CITY OF WACONIA PLANNING COMMISSION AGENDA

- A. PUBLIC HEARING: Sudheimer Retail Addition PRELIMINARY AND FINAL PLAT APPLICATION submitted by KTJ 290, LLC, for the properties located at 10590 and 10594 10th Street West. Pages 6-16

- B. SITE PLAN and DESIGN REVIEW: Request submitted by KTJ 290, LLC, for a proposed freestanding retail building, multi-tenant building and other site improvements - Lot 1, Block 1, Sudheimer Retail Addition. Pages 17-31

The City of Waconia staff have reviewed the proposed Preliminary Plat application for the Sudheimer Retail Addition commercial development drafted by Kimley-Horn Associates, Inc. dated August 31st, 2016 and provide the following review and comments:

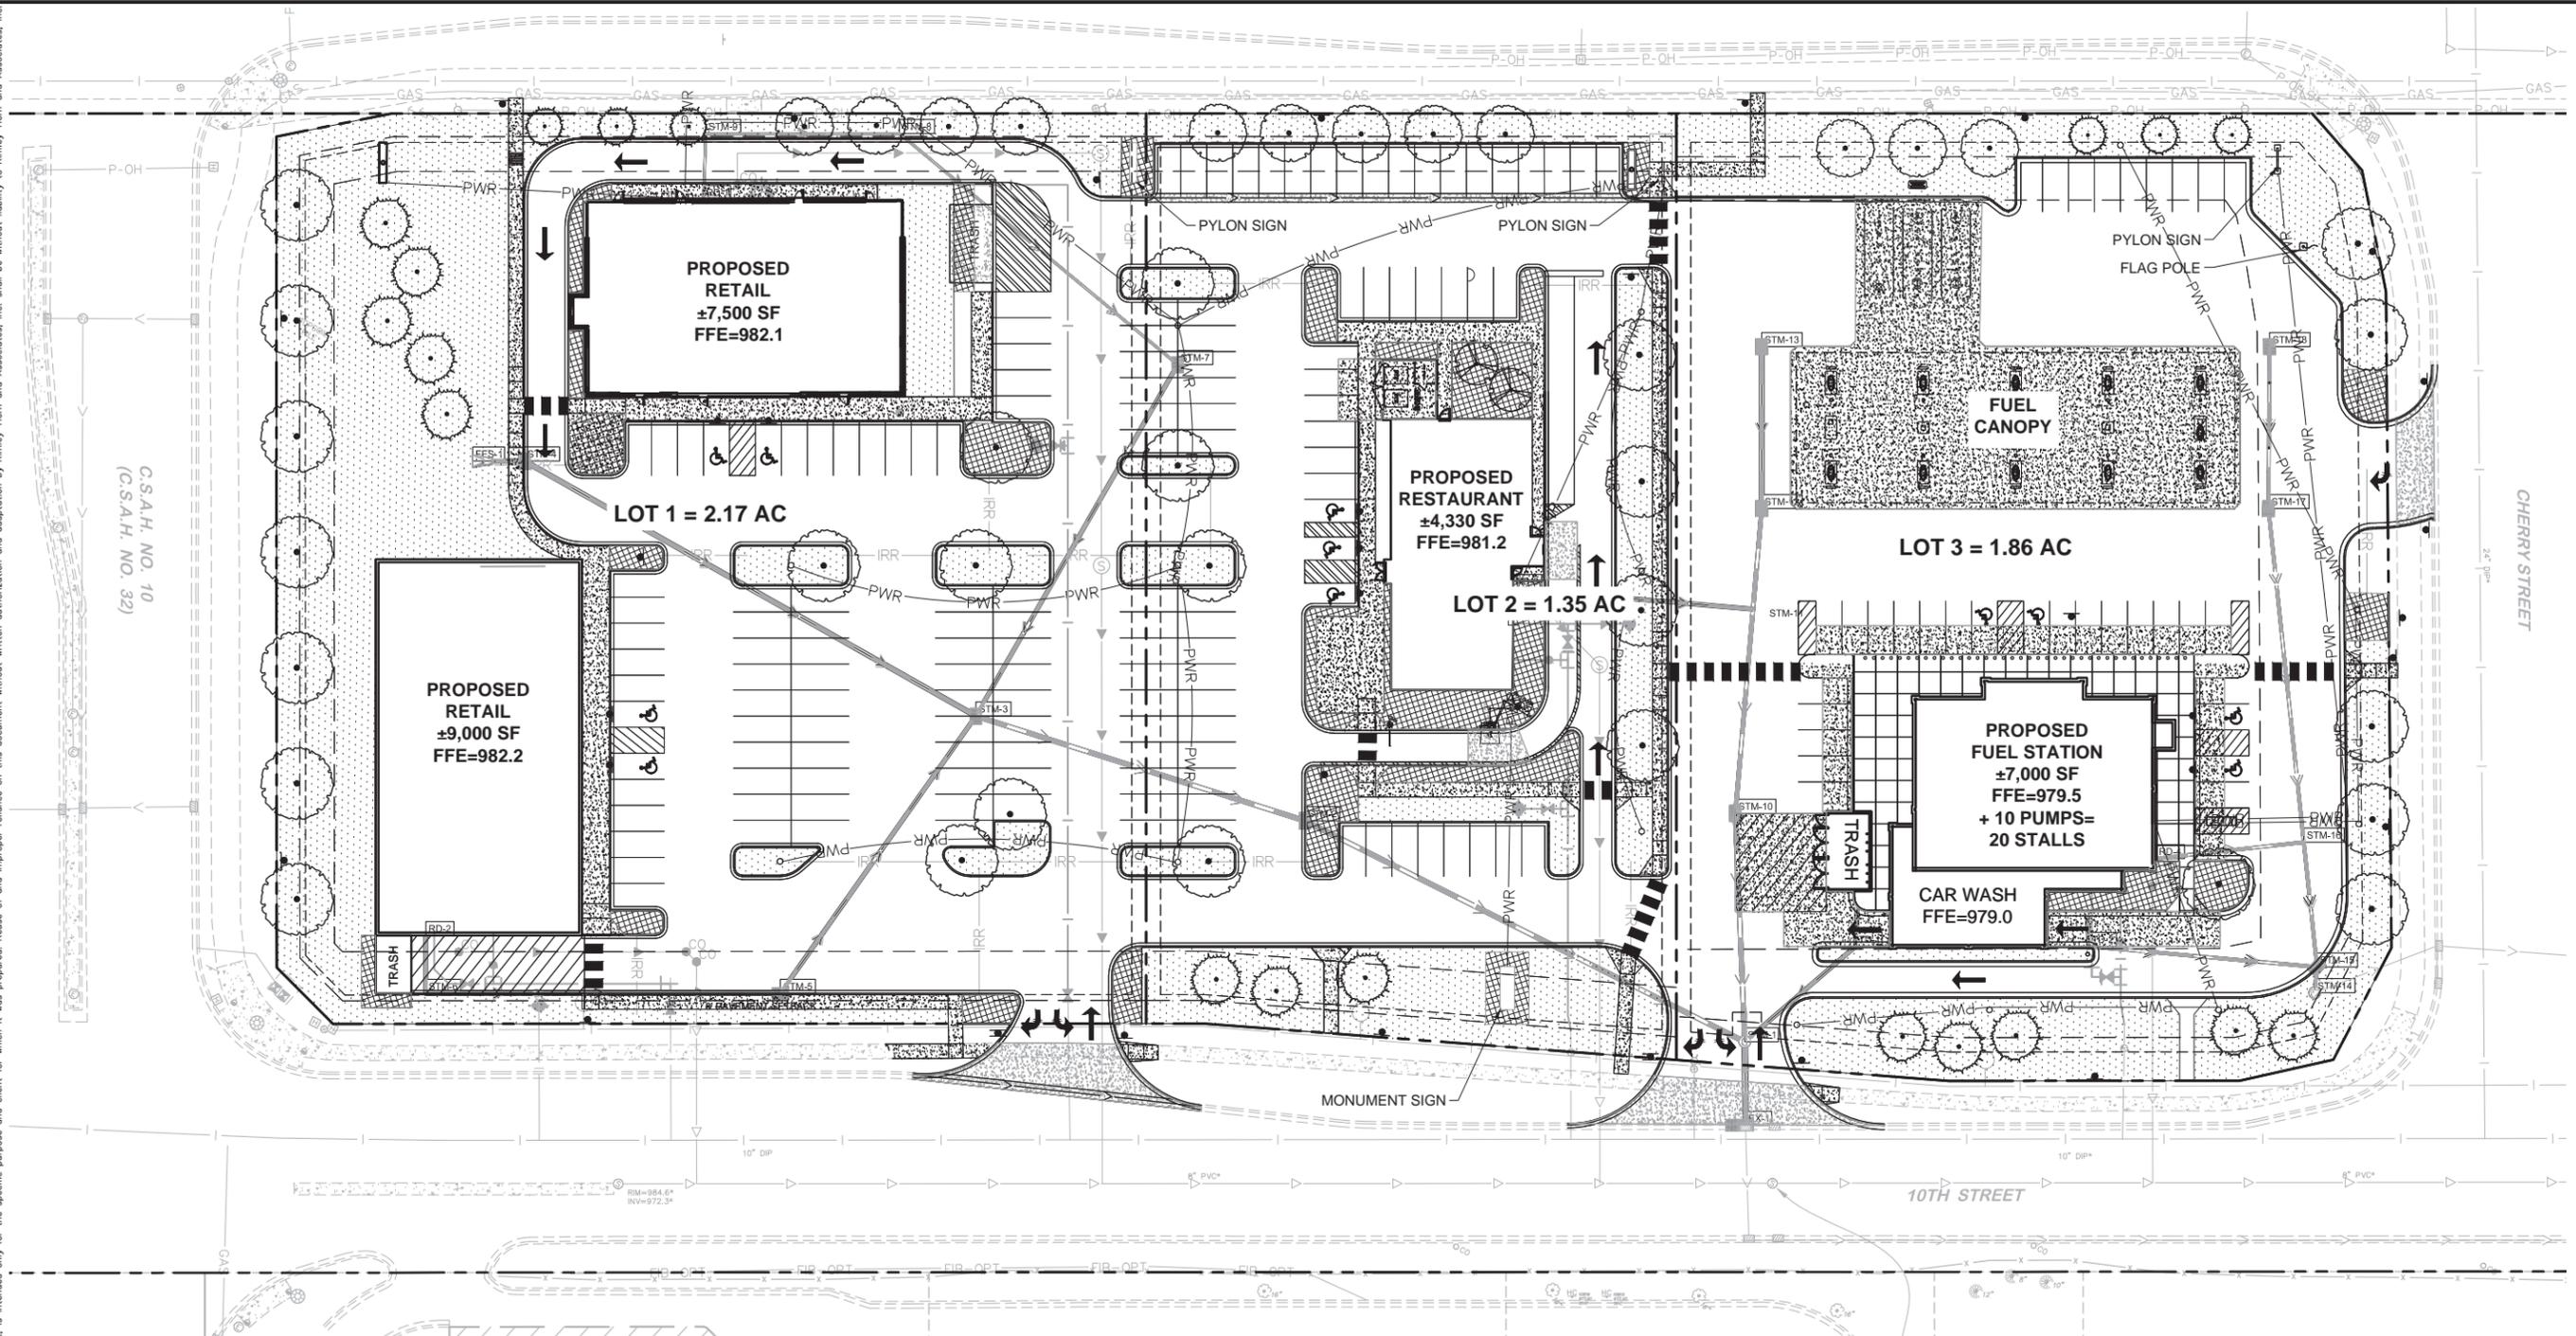
The applicant is proposing 24 trees, which when considered as part of the whole is in compliance with City Ordinance requirements. It should be further clarified that the 17 additional trees required for the frontage of the entire development along Hwy 5 are required to meet the 3 inch/8 ft. standard rather than the typical 2.5 inch deciduous and the 6 ft. coniferous tree standards. The landscape plans shall be modified to clarify where the 17 larger trees shall be planted throughout the development.

Design Response: The proposed landscape plan indicates conformance with items 1 and 3 above. The applicant should clarify how item 2 above will be met.

7. The plans shall be revised to include bicycle parking consistent with the Pedestrian and Bicycle Access Design Standard.
8. The additional plantings required for frontage along Hwy. 5 shall be indicated on the landscape plan. The additional plantings total 17 trees for the entire site. The plantings will require a minimum 3 inch deciduous or 8 ft. coniferous tree. This is in addition to the 41 trees required per landscape requirements.

9. The complement of trees fulfilling the requirements of this policy shall be not less than 25% deciduous and not less than 33% coniferous. The landscape plan shall be revised to indicate compliance with this standard.

13. The applicant shall provide a bicycle rack on site.
14. The applicant shall revise the landscape plan to include screening consistent with the Parking Lot Landscaping Design Standard.
